Product Change Notification

110936 - 00

Change Notification #:	110936 - 00
Change Title:	Intel PRO/1000 MT Dual Port Server Adapter, PWLA8492MTG2P20 MM#853671 (Double Barrow OEM generic), and Intel PRO/1000 GT Dual Port Server Adapters, PWLA8492GTG2L20 MM#885972, PWLA8492GTG2P20 MM#885846 (Double Barrow II LF OEM generic) PCN 110936-00 Label Updating KCC (Korean Communications Commission) logo to the new KC logo on PB (printed board) and all box labels
Date of Publication:	Aug 12, 2011

New KC logo, Date of Manufacture, Product Identification number, Made in COO (Picture 4, all of the information showing in Picture 4 is for example only and may not reflect actual data)

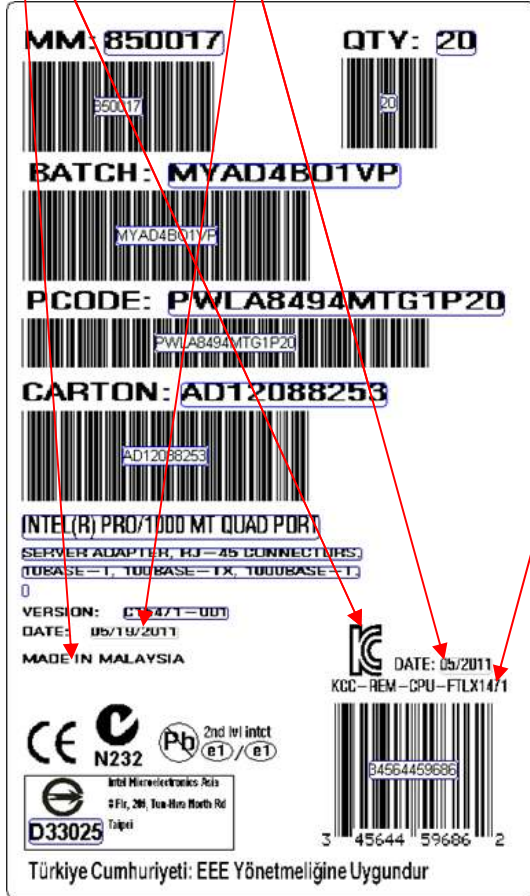
To comply with new regulations from Korea, Intel will be adding the new KC logo to the Printed Board (PB) as a label. The label will be added to either the front or the back of the PB depending on space constraints. The new KC logo will also be added to all box labels (product box label and over-pak box label). **(see pictures 1, 3 & 4)**

Picture 4 showing new KC logo on box label. The box label already contains the Made in Country of Origin (COO) and the Date of Manufacture, this information will also show on the KC label.
